ADDENDA #I

January 25, 2023

PROJECT: **Redevelopment of Onoville Marina Park
Phase I Site Improvements
704 West Perimeter Road, Frewsburg, NY**
BEARDSLEY PROJECT NUMBER – 22034.001

ARCHITECT: **BEARDSLEY ARCHITECTS + ENGINEERS**
**64 South Street
Auburn, NY 13021**

Item No 5. Detail A/C-406

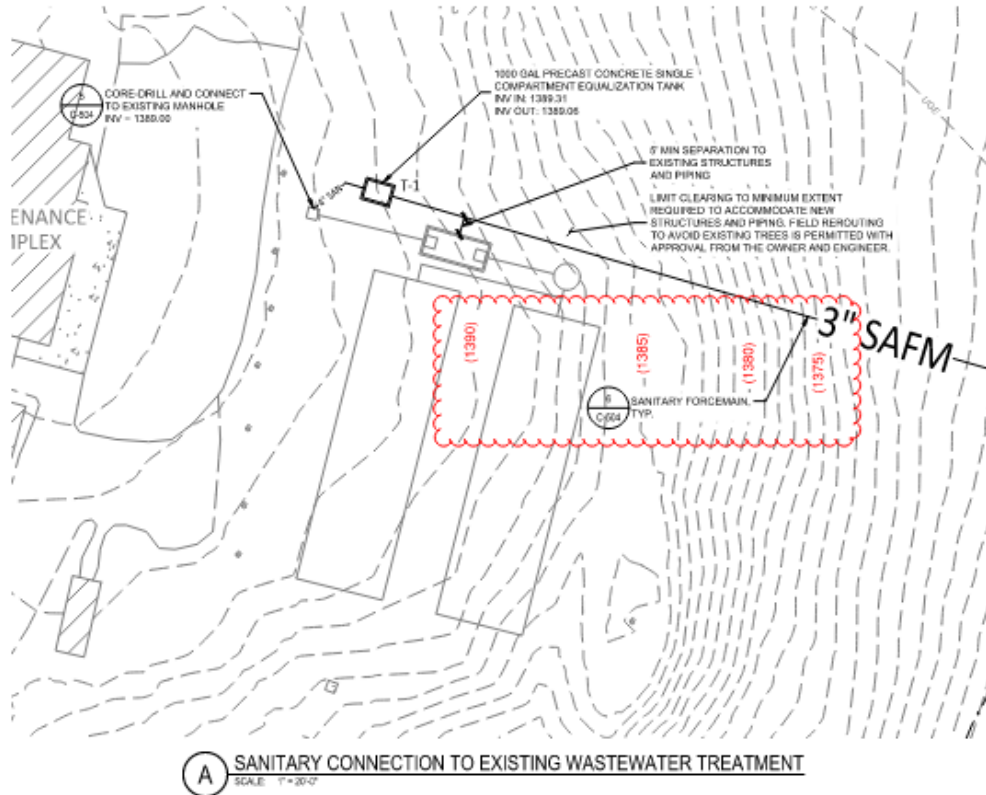
Enlarged plan did not include labels on the associated contours – see notations below.
